**DRAFT DESIGN REPORT**  
*FOR*  
**BURKE CREEK HIGHWAY 50 CROSSING AND  
REALIGNMENT PROJECT, PHASE I**  
*STATELINE, NEVADA*

**March 2016**

<b>Comments on Burke Creek HWY 50 Crossing and Realignment Project</b>				
			<b>Commenter: Erik Nilssen P.E., Douglas County</b>	<b>Responder: NTC Engineering</b>
<b>Comment #</b>	<b>Document</b>	<b>Page</b>	<b>Comment</b>	<b>Response</b>
DC-1	50% Plans	ii	Douglas County will need a set of as-built plans as well.	Noted
DC-2	50% Plans	ii	Note seems like it does not apply. Plenty of work will take place outside of the NDOT ROW.	Irrelevant portion of note has been deleted
DC-3	50% Plans	G-1	"Potential Access to Upstream Work Via Existing Sierra Colina Road" needs to be clarified. Is this an access or not? Contractor needs to know for sure what they can use.	The access point from the Douglas County ball fields has been made the primary access point for upstream improvements on the 90% plans. For separate Sierra Colina mitigation work, the Contractor may choose to use the Sierra Colina access point.

SHEET  
**G-2**  
5 OF 19

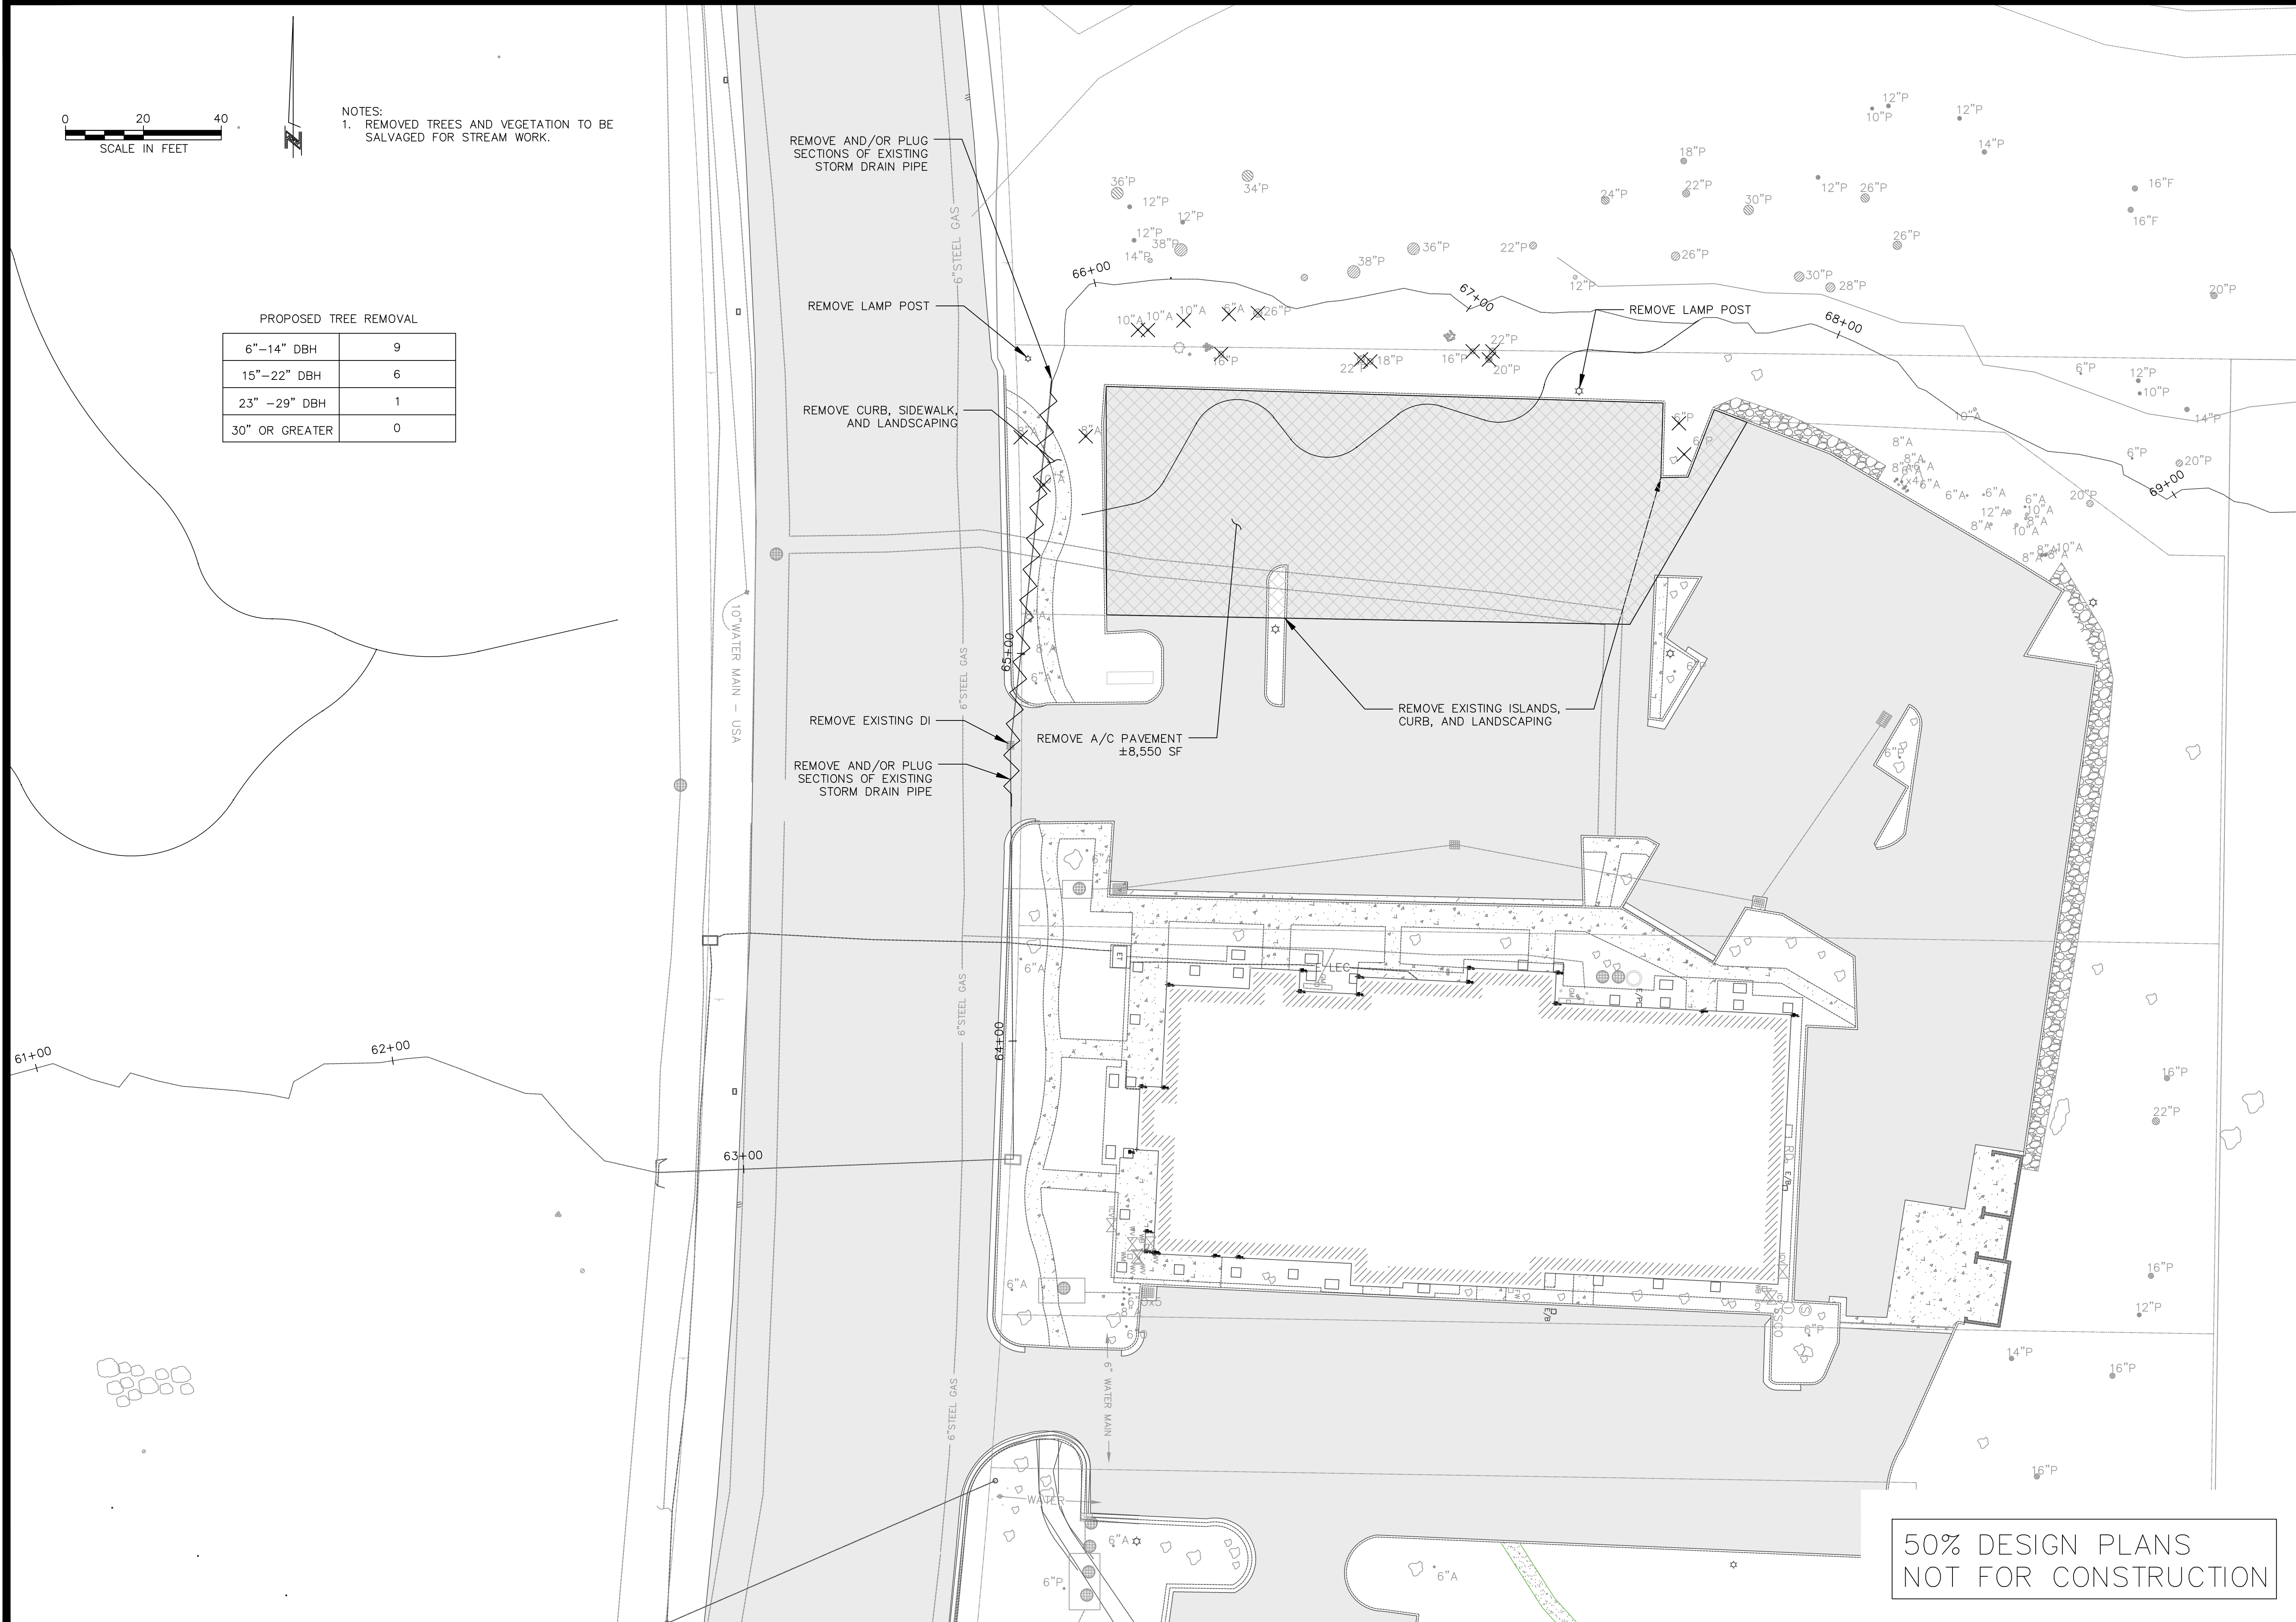
DC-12	50% Plans	G-2	Note "remove existing lamp post." Are you returning to the property owner? Are you going to reinstall? It's private property.	The lamp post to be removed is on Douglas County Property. The Contractor will dispose of the lamp post.
DC-13	50% Plans	G-2	The removal line on the east landscape island should match Sheet 14. Adjust the line so that it does not remove any of the concrete from the landscape island.	A note has been added to the plans to fit the vertical curb to the existing island. The island concrete is in poor condition and may need to be replaced.
DC-14	50% Plans	G-2	Revise note to "Remove and Dispose of Curb, Sidewalk, and Landscaping." There should be a hatch to show the limits of removal. There is on Sheet 10, but is should be shown on this sheet as well.	Corrected on 90% plans
DC-15	50% Plans	G-2	Previously, Douglas County required sidewalk along US 50 to be replaced. I don't see that sidewalk replaced in the plan set.	The new sidewalk alignment is shown in the 90% Plans.

SHEET  
**CS-2**  
7 OF 19

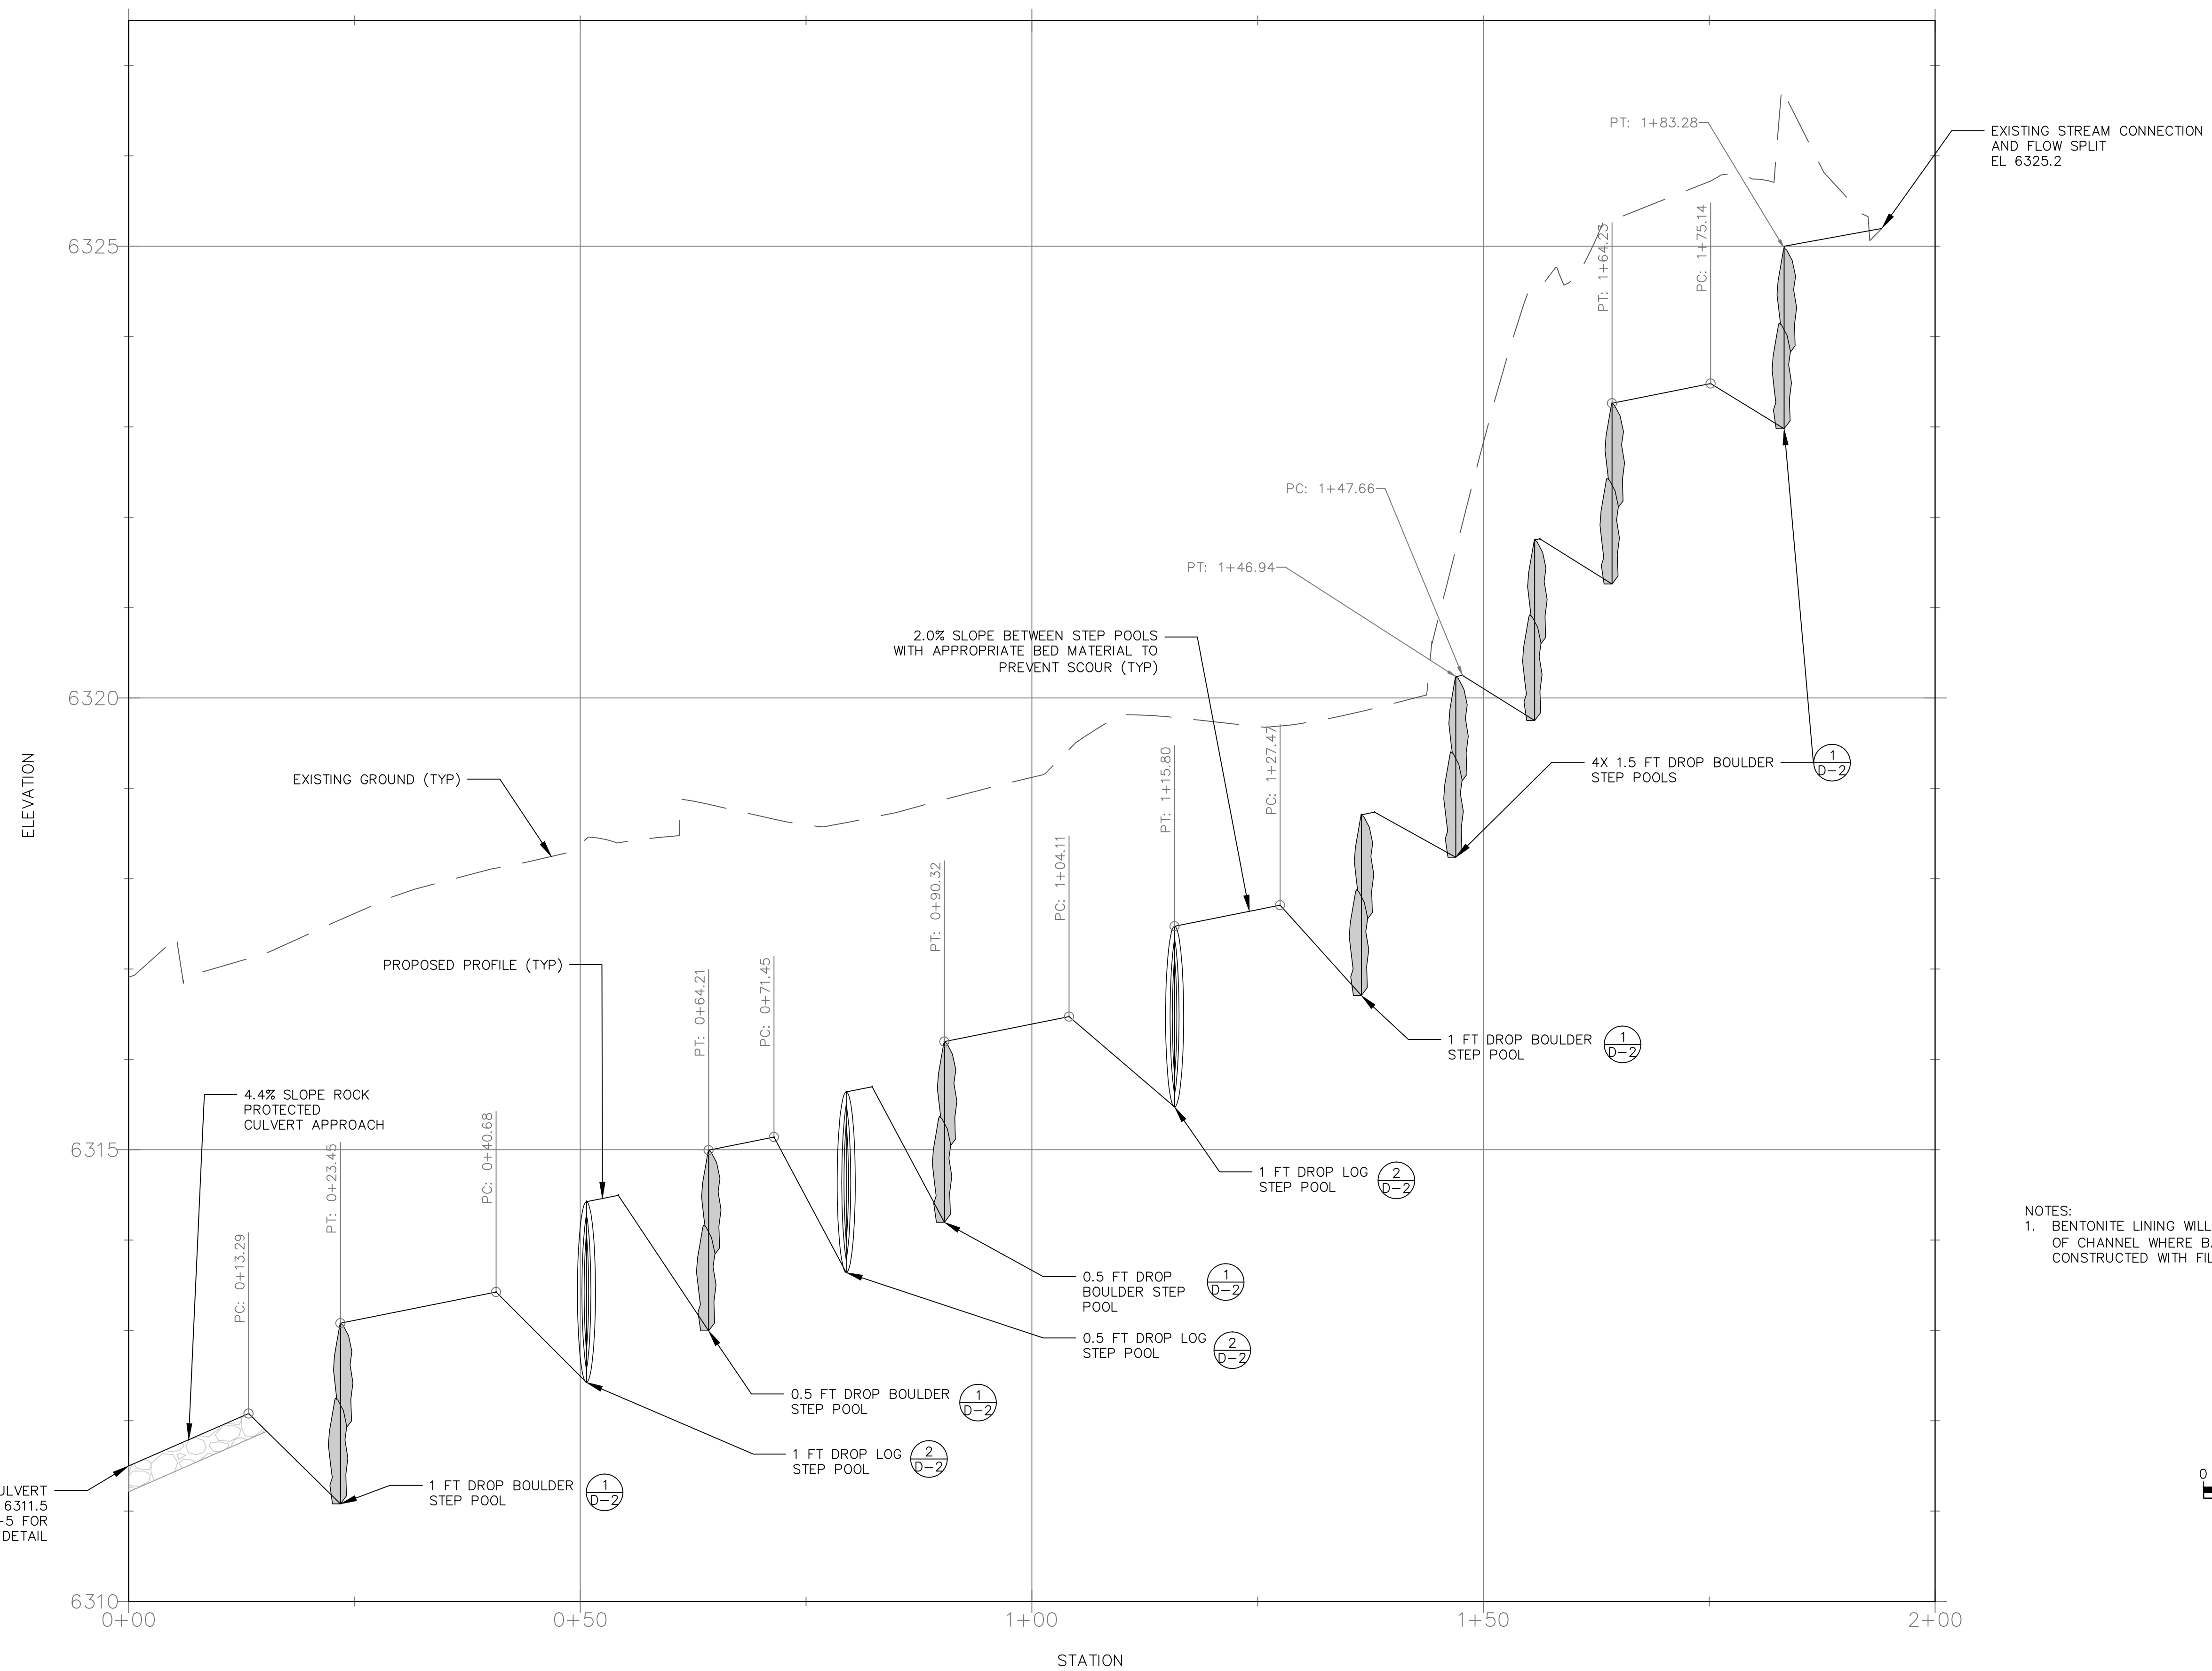
DC-18	50% Plans	CS-2	Need detail for new concrete to be poured against old.	A note has been added to the sidewalk detail.
DC-19	50% Plans	CS-2	Provide stationing for Log & Boulder Step Pools.	Stationing has been provided in the 90% details.
DC-20	50% Plans	CD-1	No stationing exists. I have no idea where this stretch of road is.	The existing NDOT highway alignment has been included with the 90% design.
DC-21	50% Plans	CD-2	Note "Construct Transition to Vertical Curb" provide detail for this transition.	This improvement was eliminated from the design.
DC-22	50% Plans	CD-2	Note "Regrade and Repave Driveway" why is this in the scope? If we do need to repave it, we need to callout the stationing for the removal limits. We also need to provide a detail that shows the thickness of pavement.	This improvement was eliminated from the design.
DC-23	50% Plans	CD-2	I am confused by the two small areas that call for pavement removal and revegetate. Won't the entire County parcel be revegetated? We should show the revegetate symbol across the whole parcel.	These areas were eliminated because the private property owner did not wish to be a project partner. Revegetation is called out on the Revegetation Plan and/or specified in the Special Provisions.
